Serial No.: 09/975,840 Filed: 10/11/2001
For: Methods And Systems For Forming Embedded DRAM For An MIM Capacitor
Attorney Doc. No.: 67,200-547

MARK-UP COPY

FIG. 10

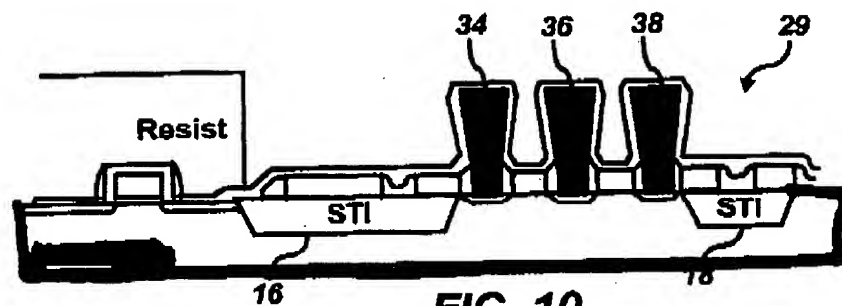
Regarding Fig. 10, the Examiner stated that space TEOS is not shown. Applicant points out that it is not necessary to show a space TEOS, because the

specification clearly points out that Fig. 10 shows the results of a TEOS wet dip. Also, TEOS is discussed thoroughly with respect to Fig. 17. The figures in their totality, including the specification and background provide sufficient enablement thereof. Applicant therefore asserts that this issue has now been removed.

FIG. 12

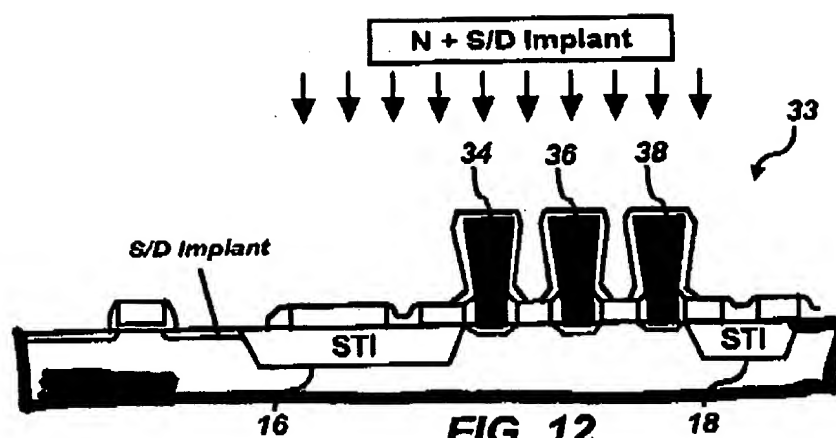
Regarding Fig. 12, the Examiner stated that it is not clear whether S/D implant is done only in the DRAM area. Applicant respectfully disagrees with this assessment. The box labeled "N+S/D Implant" is located sufficiently above the substrate and components thereof to indicate that the implant operation occurs across the entire top thereof. Applicant therefore asserts that this issue has now been removed.

**FIG. 17**

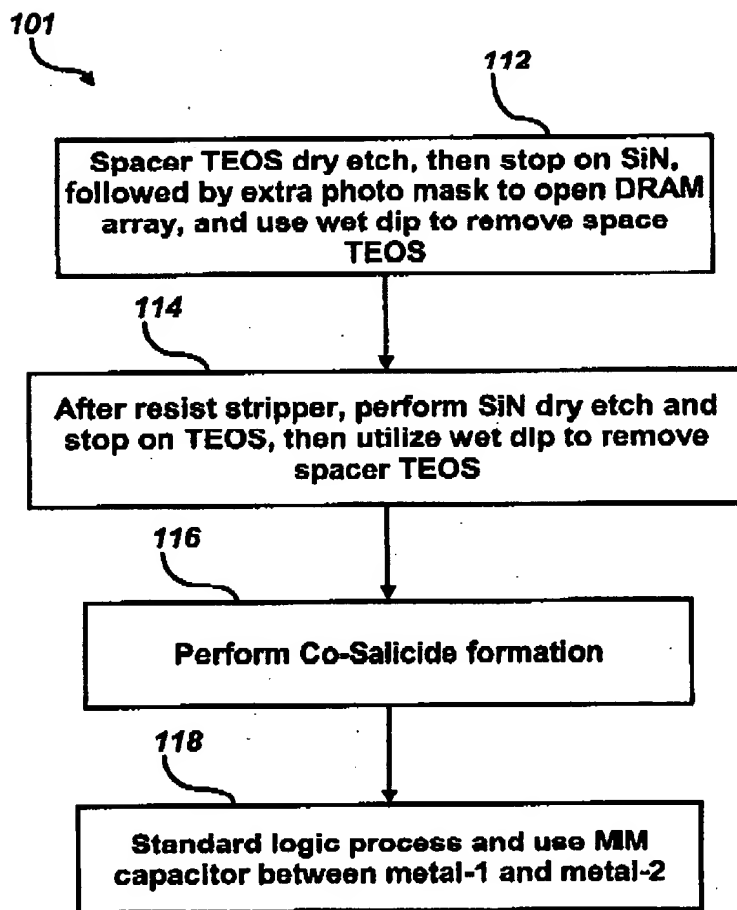
Regarding Fig. 15, the Examiner argued that the tungsten plug is not shown. Applicant has modified Fig. 15 to point out some of the plug formations. Additionally, it is not necessary to show an M2 layer because the presence of "M1" implies additional layers; otherwise if "M1" were only one layer, it would be expressed simply as "M" instead of "M1". Applicant has, however, modified Fig. 15, to show M2. Applicant therefore asserts that this issue has now been removed. Regarding Fig. 17, the Examiner stated that it is not clear what RPO means. Applicant has modified Fig. 17 to remove RPO from Fig. 17. Applicant therefore asserts that this issue has now been removed.
